LAND USE APPLICATION COMPLETENESS REVIEW

Subject Property: 1105 Front Street NE

Reference Nos.: 24-106451-PLN (Class 3 Site Plan Review, Tentative Subdivision Plan, Class 1 & 2 Adjustment, Class 2 Driveway Approach Permit)

TENTATIVE PLAT
 THE CANNERY
 FUND
 SALEM, OREGON

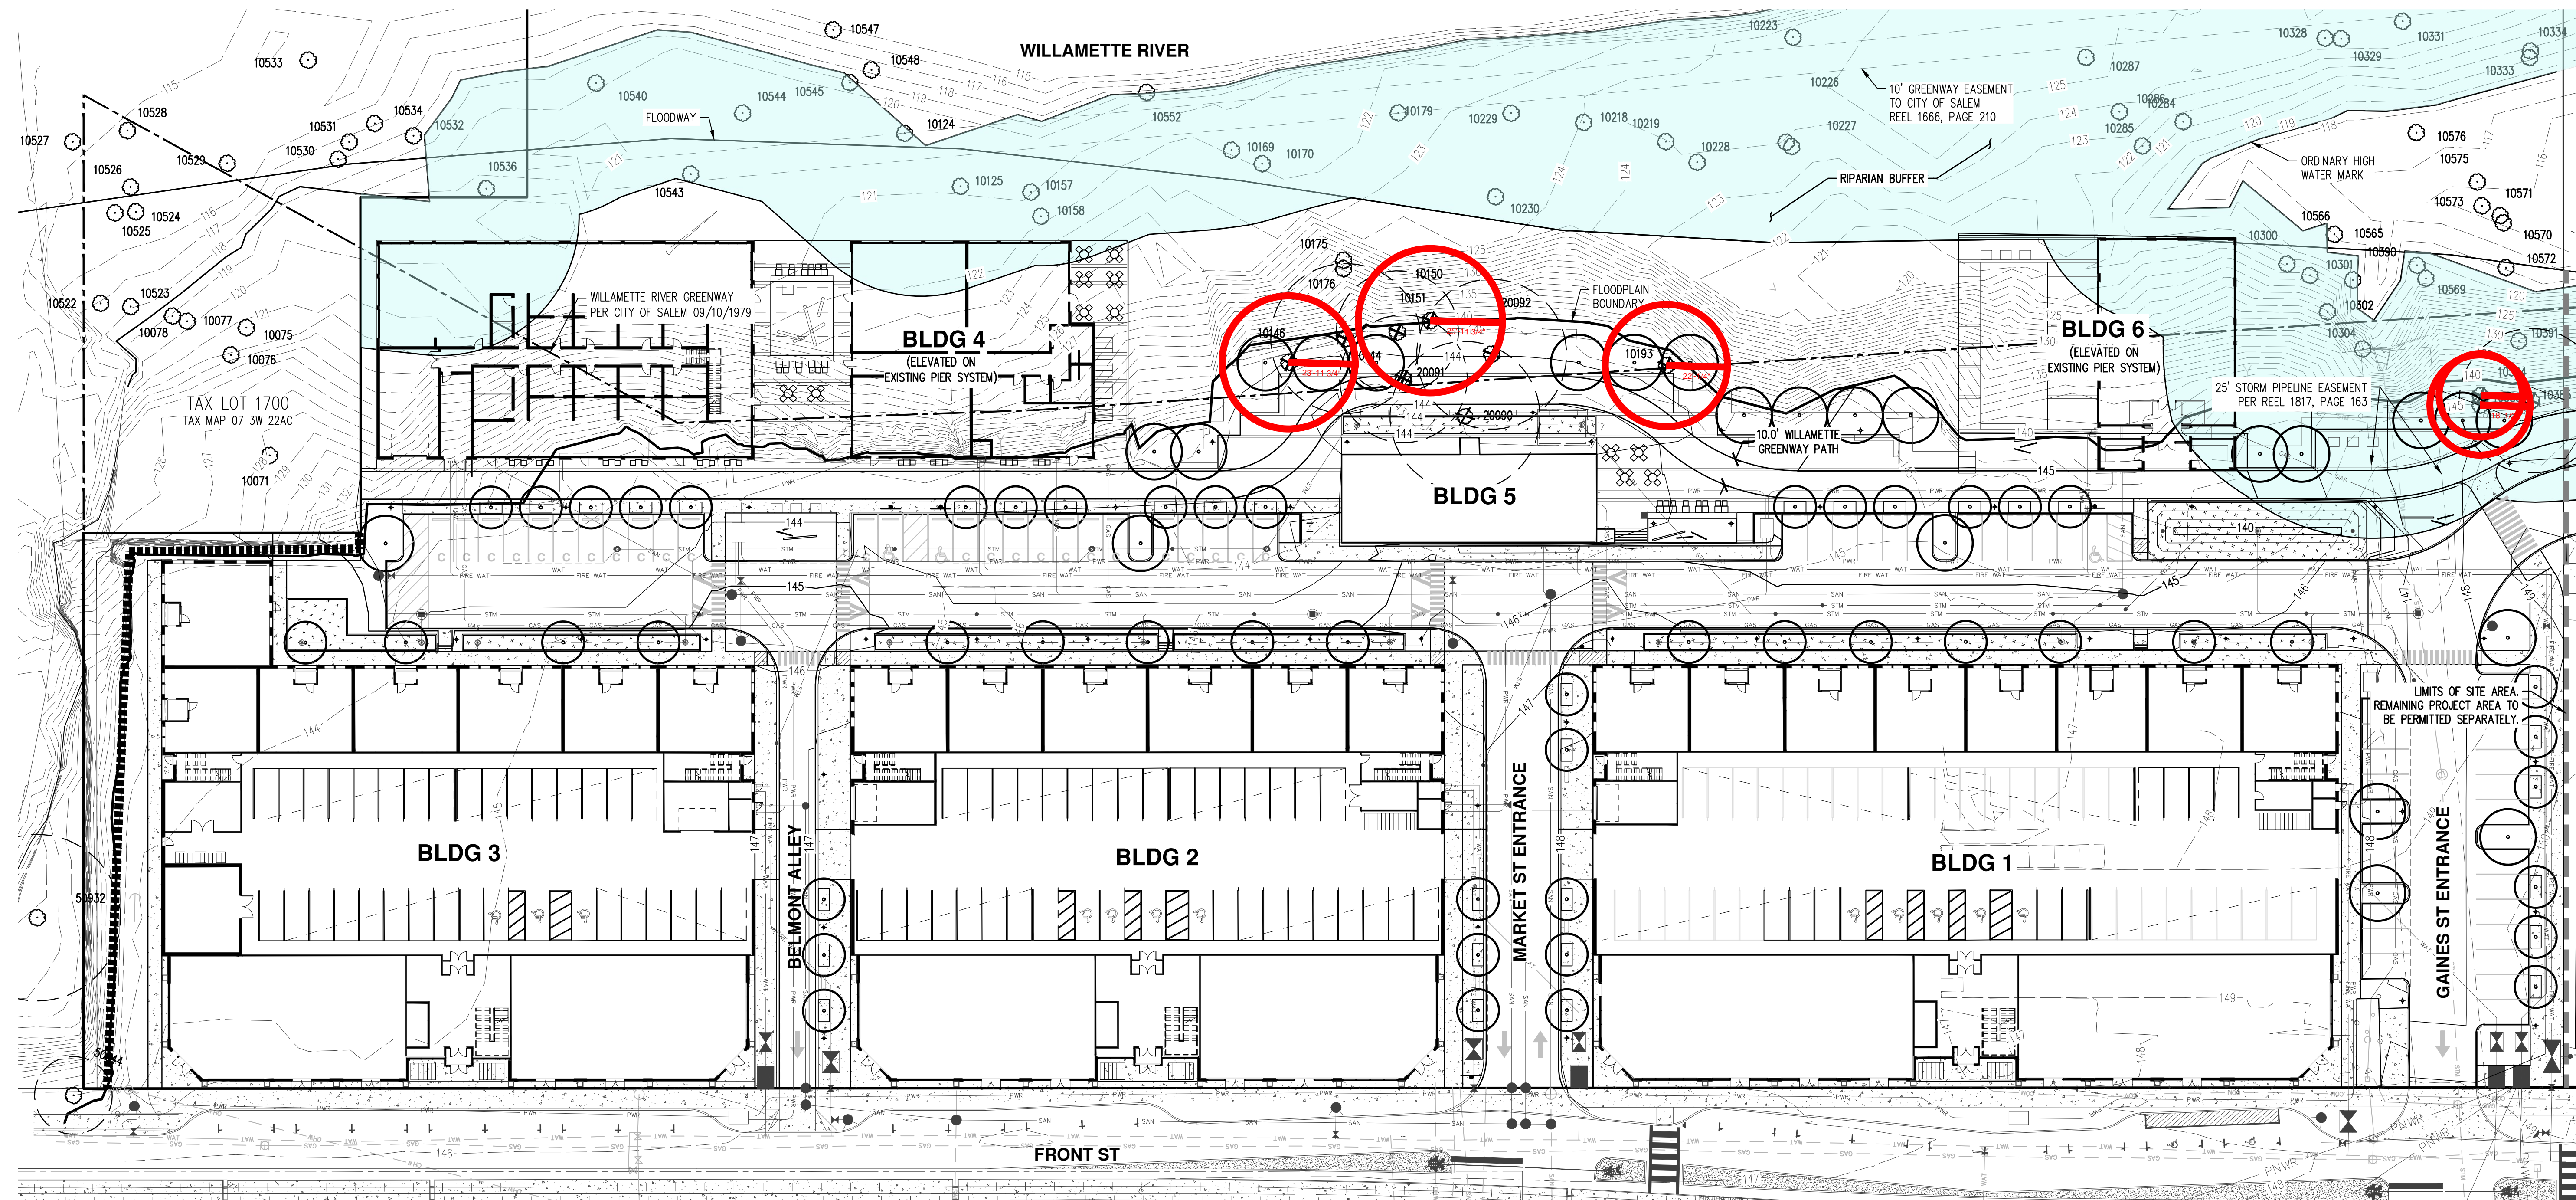
FROM There's a 1-foot reserve strip along this portion of the site. Based on what's shown on the Assessor's map, it appears that the reserve strip extends for a distance of 298.55 ft. along Front Street rather than 278.73 ft.

Willamette Greenway Compatibility Review Boundary:
 -Tentative subdivision plan needs to be revised to also show the Willamette Greenway Compatibility Review Boundary.

PRELIMINARY TREE TABLE
 THE CANNERY
 FUND
 SALEM, OREGON
 PRELIMINARY
 NOT FOR
 CONSTRUCTION

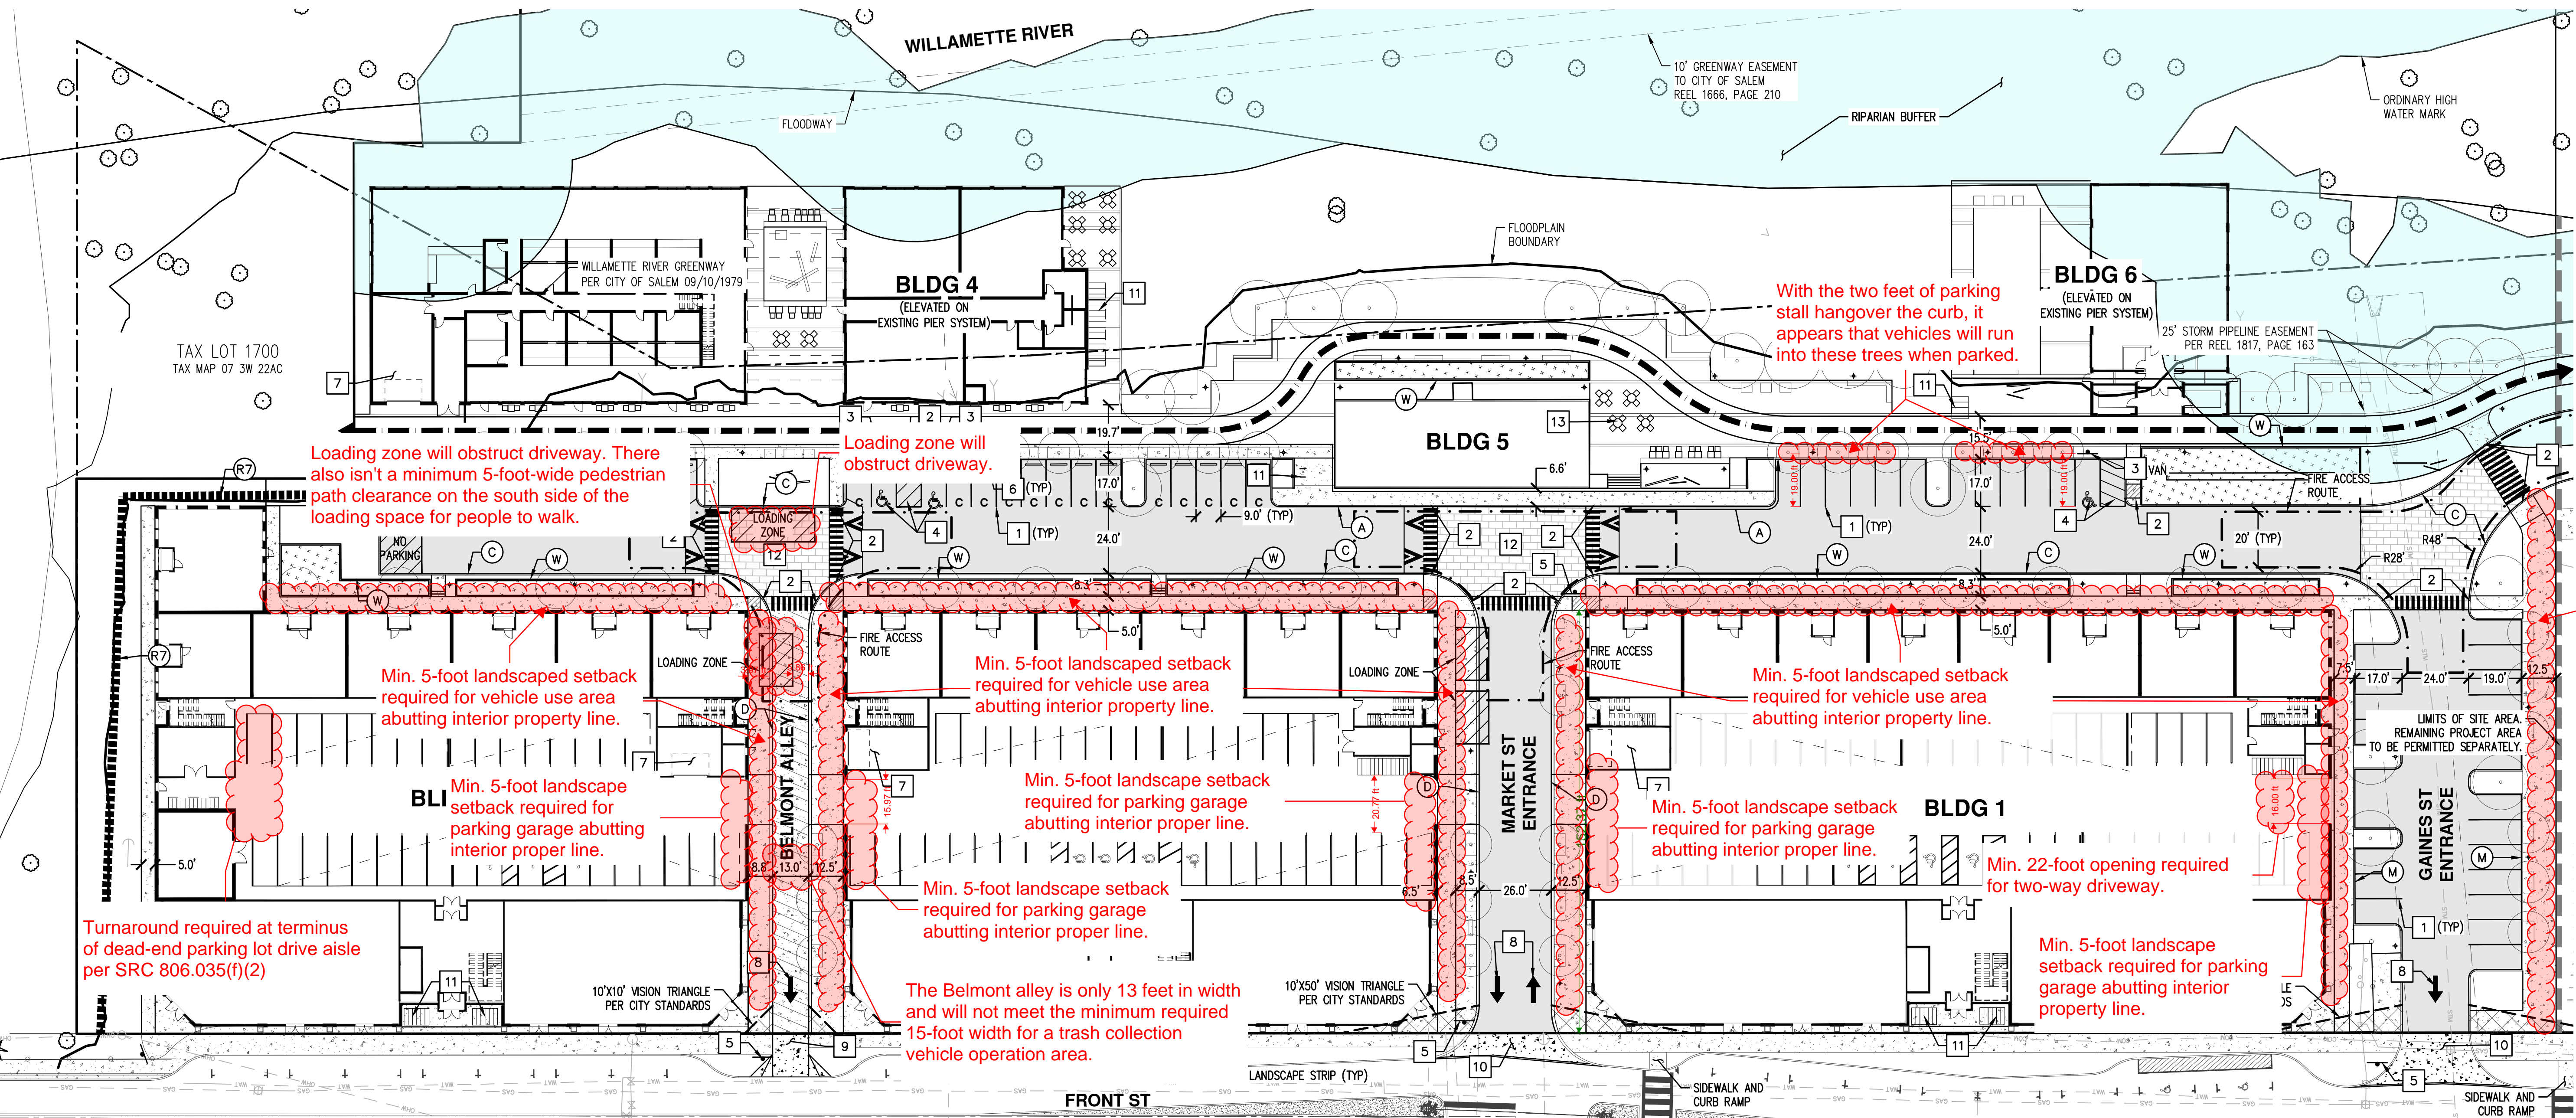
Riparian Corridor Boundaries
 Tree Removal & Preservation Plan needs to be revised to show the 75-foot-wide riparian corridor of the Willamette River and the 50-foot-wide riparian corridor of Mill Creek.

-Tree 10144: Not clear why this tree is proposed for removal. Tree is in good condition with good health rating and good structure rating. It doesn't appear that more than 30% of the critical root zone will be disturbed with the construction of the path.

-Tree 10151: Not clear why this tree is proposed for removal. Tree only has a slight lean and is identified as having a good health rating and good structure rating. It doesn't appear that more than 30% of the critical root zone of this tree will be disturbed with the construction of the path.

-Tree 10193: Not clear why this tree is proposed for removal. Tree is in good condition with good health and good structure rating. It doesn't appear that more than 30% of the critical root zone of this tree will be disturbed with the construction of the path.

-Tree 10383: Not clear why this tree is proposed for removal. Tree not evaluated by arborist but it doesn't look like more than 30% of the critical root zone of the tree will be disturbed with the construction of the path.

-Tree 10384: Not clear why this tree is proposed for removal. Tree not evaluated by arborist but it doesn't look like more than 30% of the critical root zone of the tree will be disturbed with the construction of the path.

SRC 808.030(a)(2)(G) exempts the removal of trees and native vegetation within a riparian corridor from the requirement to obtain a tree removal permit but only when the removal of the tree or native vegetation is necessary for public trail or public park development and maintenance. It doesn't appear, however, that all of the trees identified for removal need to be removed for the construction of the Willamette Greenway path.

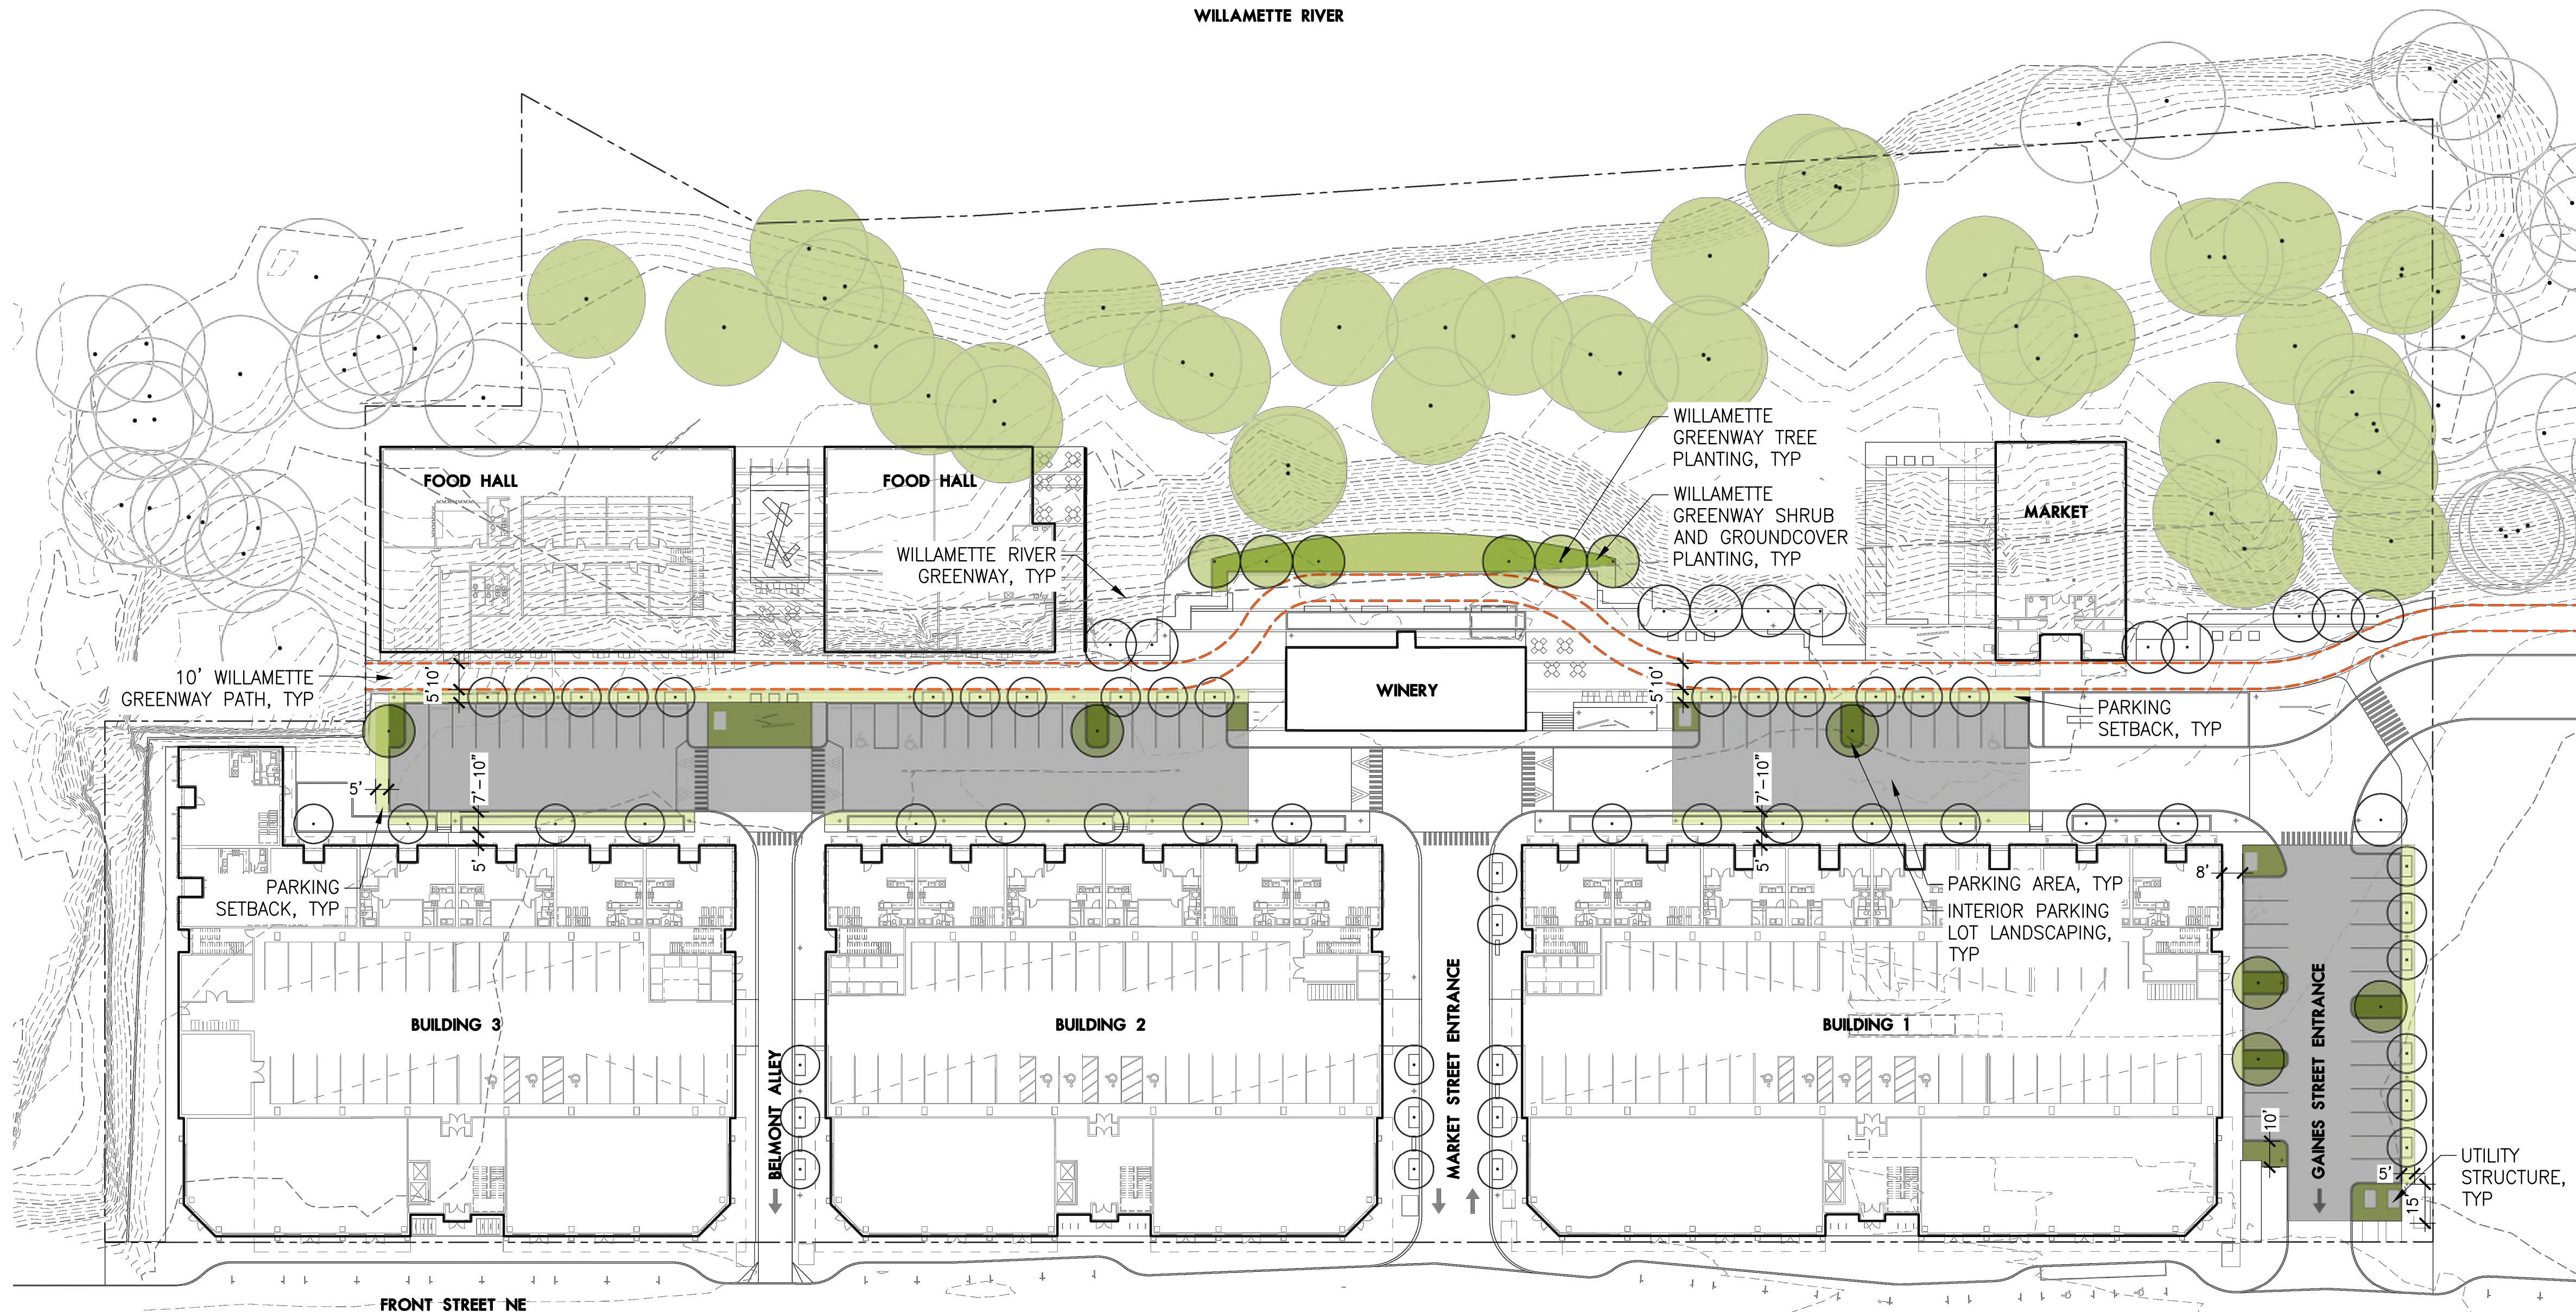
Loading zone will obstruct driveway. There also isn't a minimum 5-foot-wide pedestrian path clearance on the south side of the loading space for people to walk.

Min. 5-foot landscaped setback required for vehicle use area abutting interior property line.

Min. 5-foot landscape setback required for parking garage abutting interior proper line.

Turnaround required at terminus of dead-end parking lot drive aisle per SRC 806.035(f)(2)

Loading zone will obstruct driveway.

Min. 5-foot landscaped setback required for vehicle use area abutting interior property line.

The Belmont alley is only 13 feet in width and will not meet the minimum required 15-foot width for a trash collection vehicle operation area.

With the two feet of parking stall hangover the curb, it appears that vehicles will run into these trees when parked.

Min. 22-foot opening required for two-way driveway.

Willamette Greenway Compatibility Review Boundary:
 -Site plan needs to be revised to also show the Willamette Greenway Compatibility Review Boundary.

Proposed Subdivision Lot Lines:
 -Site plan needs to be revised to clearly show the proposed new subdivision lot lines. The proposed lot lines are very difficult to distinguish on the plan due to their color being black. A different color is recommended so the proposed lot lines can be clearly seen in relation to the the building and site improvements.
